REFERENCE:	TSB: 08-098-23 GROUP 08 - Electrical	Date:	April 14, 2023	REVISION:	08-181-22
VEHICLES AFFECTED:	2022 - **2023** (WL) Jeep Grand Cherokee This bulletin applies to vehicles built on or after May 27, 2022 (MDH 0527XX) and built on or before **December 20, 2022 (MDH 1220XX).**			MARKET APPLICABILITY:	
				<input checked="" type="checkbox"/> NA	<input checked="" type="checkbox"/> MEA
				<input checked="" type="checkbox"/> SA	<input checked="" type="checkbox"/> IAP
				<input checked="" type="checkbox"/> EE	<input type="checkbox"/> CH
CUSTOMER SYMPTOM:	<p>The customer may experience a Malfunction Indicator Lamp (MIL) illumination. Upon further investigation the technician may find the following Diagnostic Trouble Code (DTC):</p> <ul style="list-style-type: none"> P152E - Engine Hood Switch 2 Circuit High. <p>Customer may also experience the following:</p> <ul style="list-style-type: none"> Start/Stop system warning light. Start/Stop inoperable. Remote start inoperable.

CAUSE:	Hood Ajar Switch (Plunger Switch)

This bulletin involves replacing the underhood switch.

Fig. 1
Plunger Style Switch

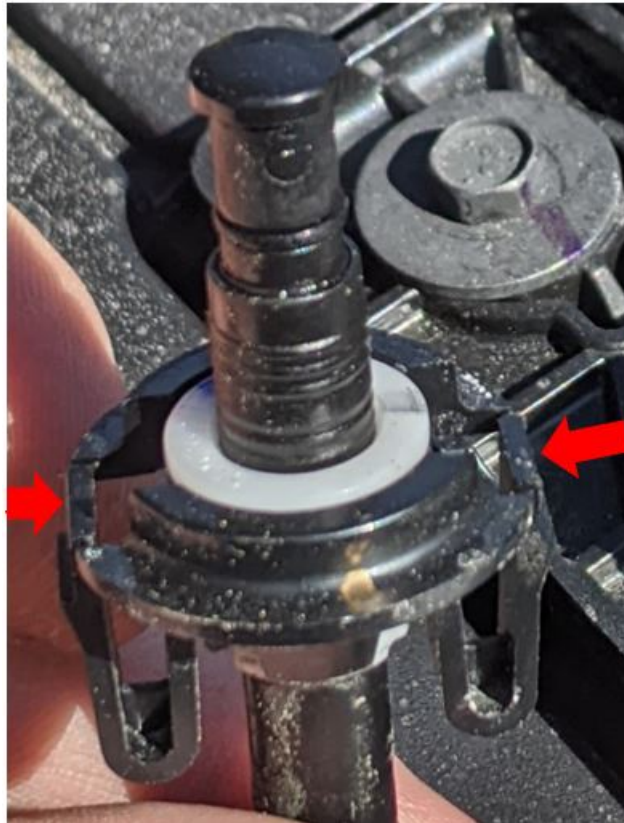
1. Remove and replace the hood ajar switch. Refer to the detailed procedures available in DealerCONNECT > Service Library> under: 08 - Electrical / 8Q - Vehicle Theft Security / Switch, Hood Ajar / Removal and Installation> Plunger (Fig. 1) .

Qty	Part No.	Description	Notes
1	**68541273AA**	Switch, Underhood	Plunger Style Switch
